Appendices

Appendix C: Facility Reports for City Buildings and Parks

Appendix D: Facility Reports for Downtown Parking Lots

Appendix E: Public Rights-of-Way Reports for City Facilities and Schools

Underground Teen Center
400 University Ave.
Los Altos, CA

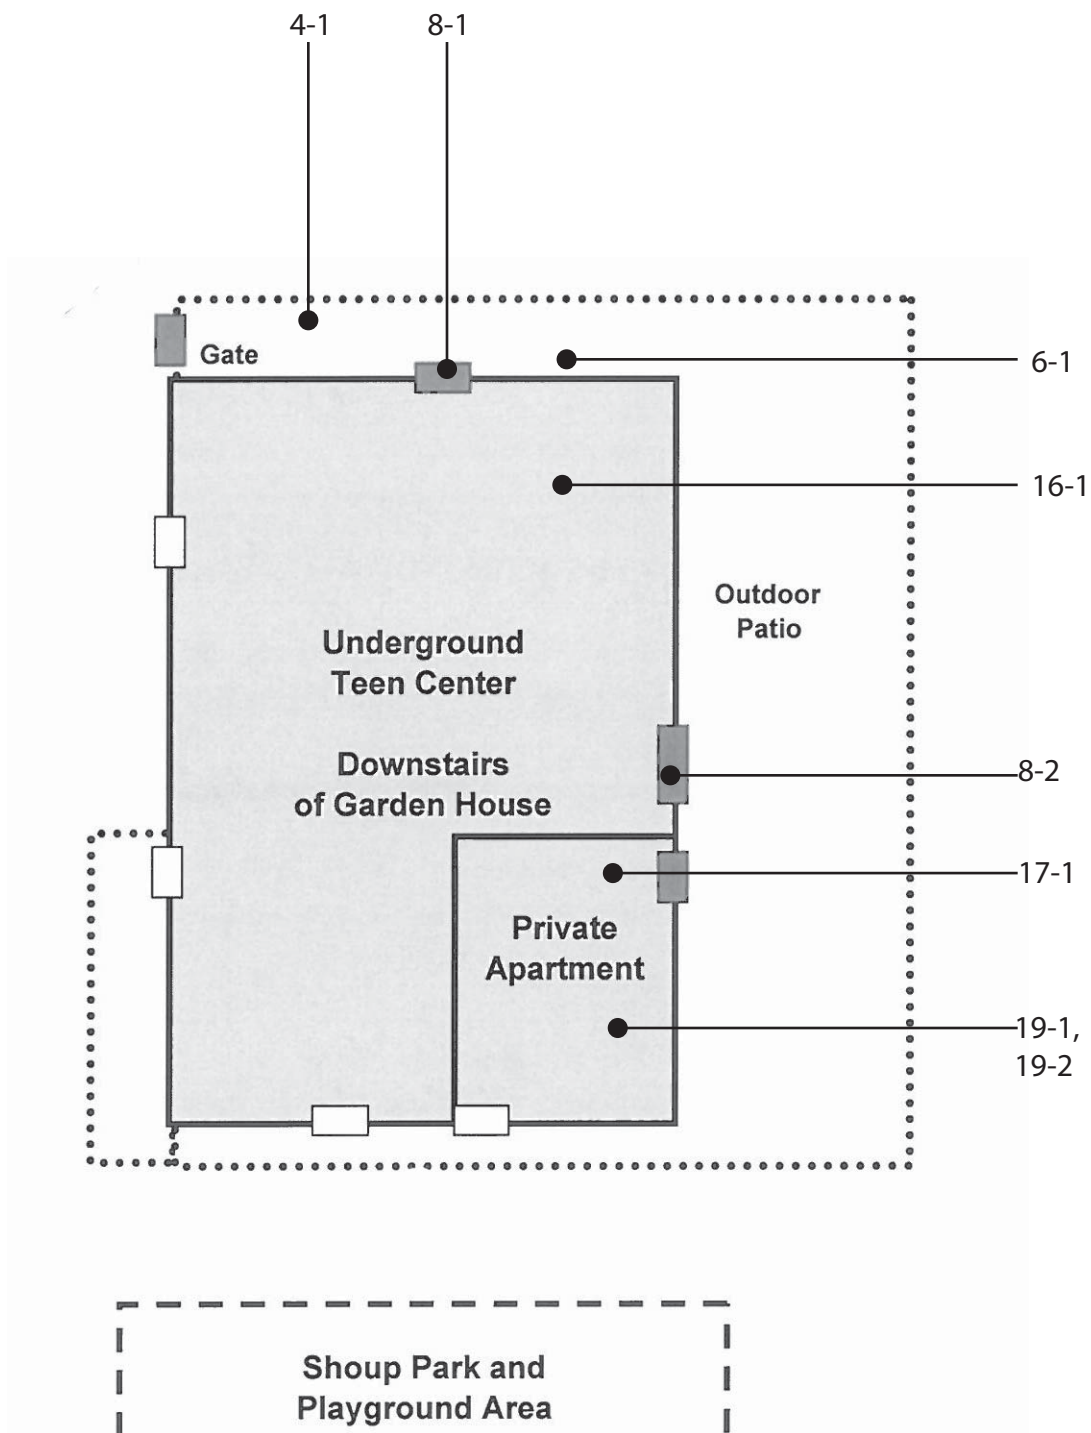
Exterior		
4 - 1	Walk	Priority: 1
Provide an accessible path of travel		\$10,000
Notes: Walkway to building entrance has slopes up to 12.2%.		
State: 1133B.7.1		
Federal: 206.2.2		
6 - 1	Stairway	Priority: 1
Install tread striping		\$150
Notes: Indicator stripes are not provided. There are six risers.		
State: 1133B.4.4		
Federal: -		
Install or modify handrails		\$5,000
Notes: Handrails are installed on one side only. Top and bottom extensions are not provided.		
State: 1133B.4.2.1, 1133B.4.2.2, 1133B.4.2.5, 1133B.4.2.6, 1133B4.1.1, 1133B4.2.3, 505.6		
Federal: 505.10.2, 505.2, 505.4, 505.5, 505.9		
Replace stairs		\$25,000
Notes: Width of stairs is 39-1/2" (44" min.)		
State: 1009.1		
Federal: -

Marymeade Park
Fremont Avenue at Lisa Lane
Los Altos, CA

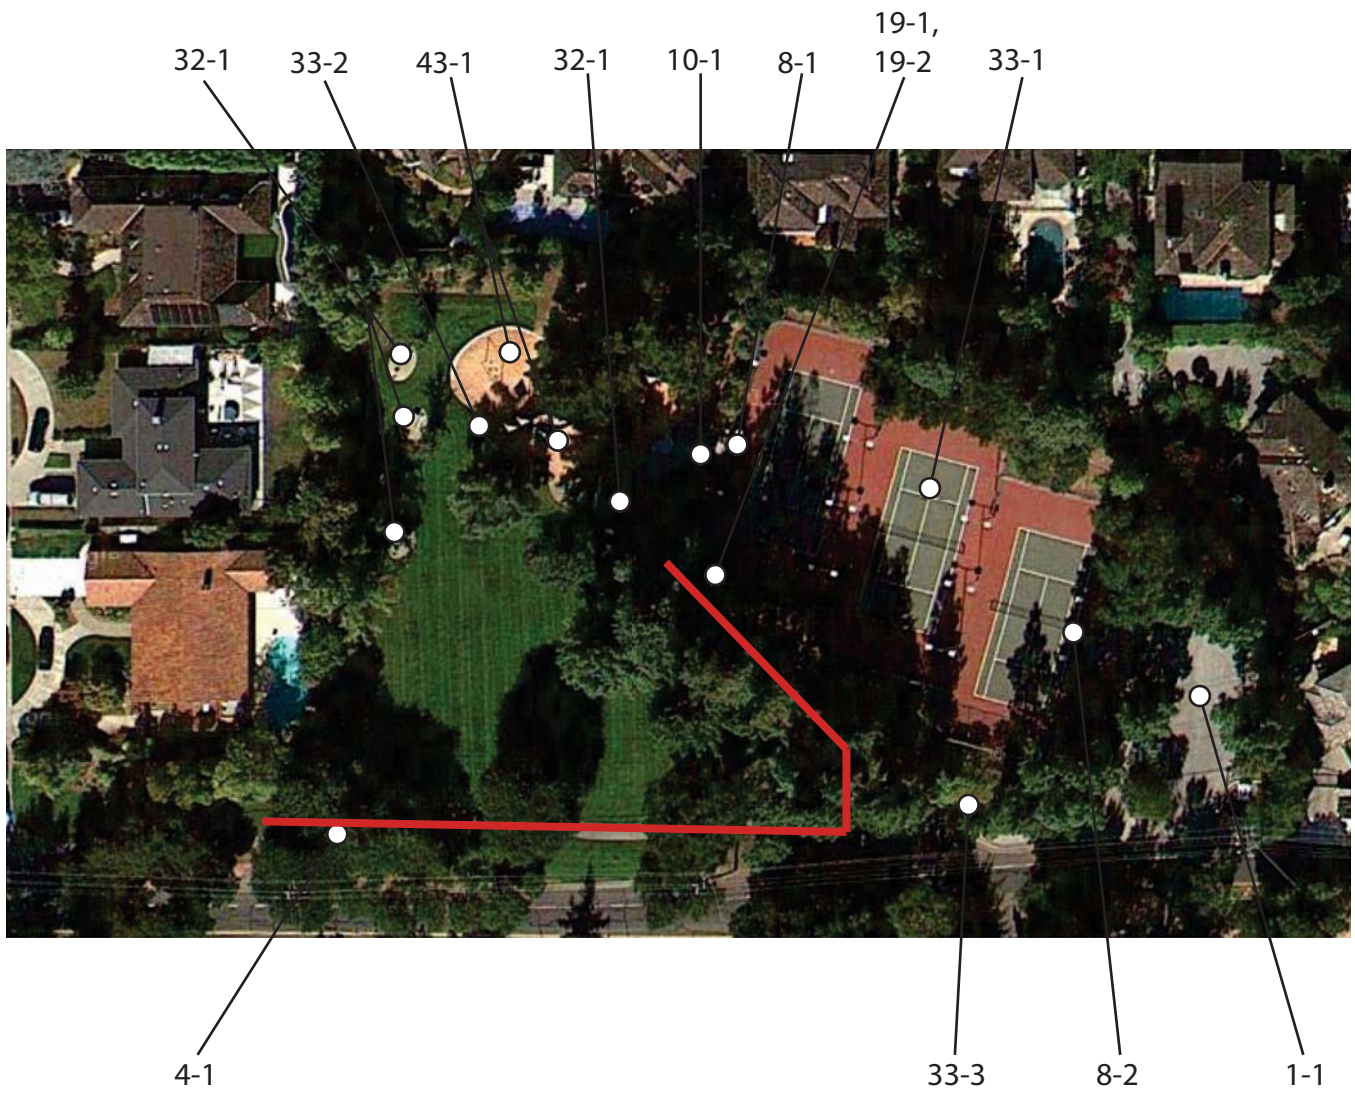
Exterior		
32 - 2	Picnic Area	Priority: 3
Provide an accessible table		\$2,500
Notes: Accessible picnic table is not provided.		
State: -		
Federal: AGODA 1011.4		
33 - 1	Outdoor Constructed Features	Priority: 3
Modify operating mechanism		\$250
Notes: Light switch in tennis courts is located 53-1/2" (48" max.)		
State: -		
Federal: AGODA 1011.3		
43 - 1	Play Equipment Area	Priority: 2
Provide an accessible path of travel		\$5,000
Notes: Curb ramp to play area is 12.4% (8.33 max.)		
State: -		
Federal: 1008.2, 302.00		
43 - 2	Play Equipment Area	Priority: 2
Ground surface safety and accessibility		\$100
Notes: There is a 4" drop off to the play area. Redistribute ground material.		
State: -		
Federal: 1008.2.6.1, 1008.2.6.2

Downtown Parking Lot 1 - PROW
Main Street at State Street
Los Altos, CA

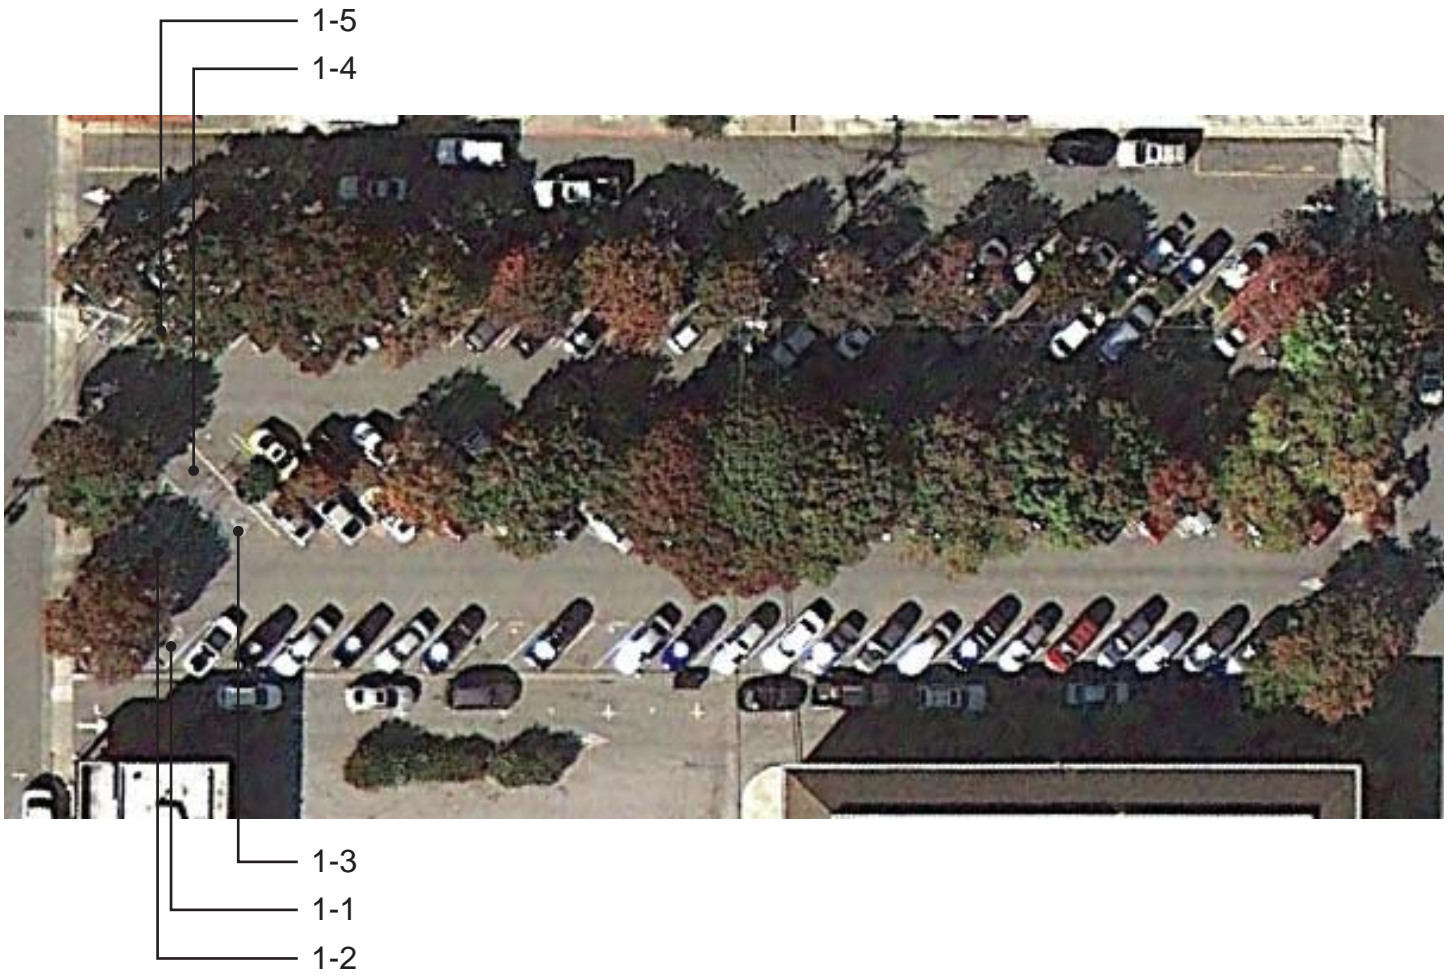
1 - 7		Parking Area	Priority: 1
Install sign			\$500
Notes:		Signs are posted at 79" AFF (80" min.)	
State:		1129B.4	
Federal:		-	
Install sign for unauthorized parking			\$0
Notes:		No posted warning at street entry regarding unauthorized use of accessible spaces and towing information.	
State:		1129B.4	
Federal:		-	
Provide or modify accessible access aisles			\$1,000
Notes:		The words "No Parking" are not painted at the access aisle. Access aisle is 17'-9" long (18' required).	
State:		1129B.3, 1129B.3.1	
Federal:		-	
Provide or modify accessible spaces			\$500
Notes:		Accessible spaces are not painted blue. ISA faded. Stall is 8' wide (9 required).	
State:		1129B.3, 1129B.4	
Federal:		-

Downtown Parking Lot 3 - PROW
Main Street at State Street
Los Altos, CA

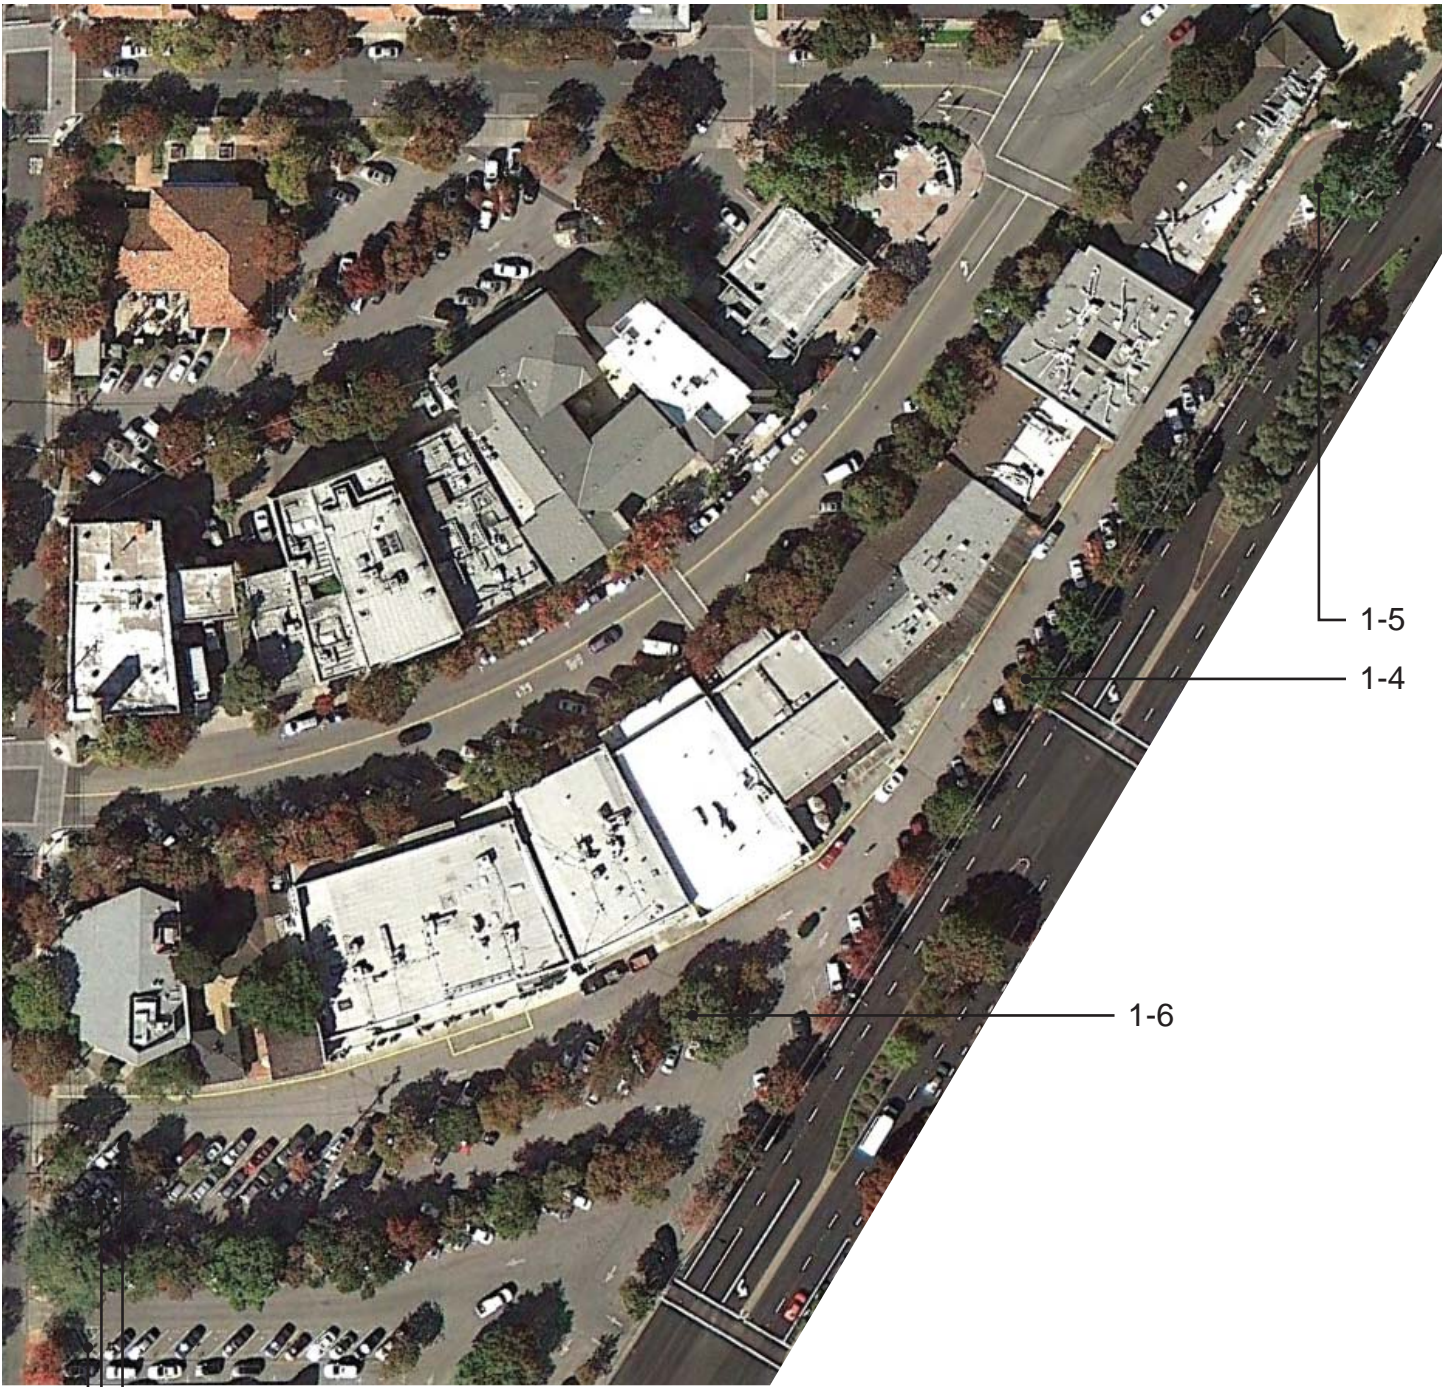
1 - 1	Parking Area	Priority: 1
	Provide or modify accessible spaces	\$3,000
Notes:	Of 59 spaces provided, 1 is accessible (3 required). Accessible space is not painted blue. ISA faded. Stall width is 8'-6" (9' min.).	
State:	1129B.1, 1129B.3, 1129B.4	
Federal:	-	
	Install sign	\$500
Notes:	No "Minimum Fine \$250" sign posted.	
State:	1129B.4	
Federal:	-	
	Provide or modify accessible access aisles	\$1,000
Notes:	The words "No Parking" are not painted at the access aisle. Access aisle ranges from 3" to 8' wide (60" min).	
State:	1129B.3, 1129B.3.1	
Federal:	-	
	Regrade surface	\$1,000
Notes:	Slopes of stall are 7%-15% at drain (2% max.) Slopes of access aisle are 3.2%-5.4% (2% max.)	
State:	1129B.3.4	
Federal:	-
